no drilling permit
IDAHO DEPARTMENT OF WATER RESOURCES

WELL INSPECTION FORM

2. OWNER: Aardena's Heida Dairy Phone: (208) 536-2187
Address: P.O. Box 140, Weiser, ID 83355

3. WELL LOCATION: Twp 6S, Rge. 1E, Sec. 11, NW 1/4 SE 1/4
County Gooding (Provide sketch map and photo on reverse.)

PHOTOS, DRAWINGS, OTHER ATTACHMENTS:

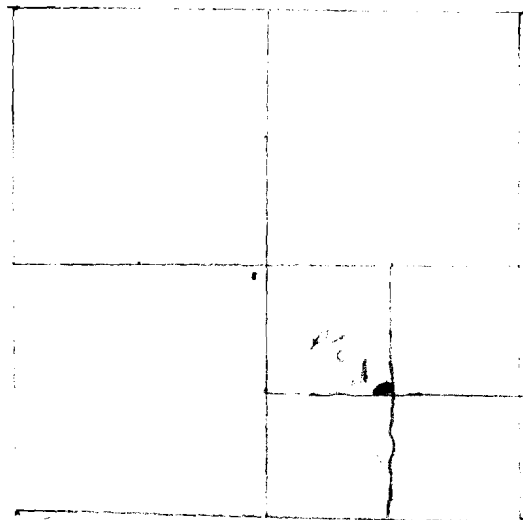
9. REMARKS: The sand from the field has blown and filled in around the pump. Therefore, ground level has raised to the level of the openings in the pump housing. The filter screen is located in the pump housing without a screen cap. This would allow rain or snow to enter the pump housing and enter the well.

THESE ARE PICTURES OF DIRT FILL-IN AROUND PUMP.
 WITH OUT A CAP ON THE ACCESS PORT & NOW OR DIRT COULD
 FILL INTO OPENING OF PUMP. THERE IS LESS THAN 2"
 CLEARANCE FROM GROUND TO PUMP VENT.
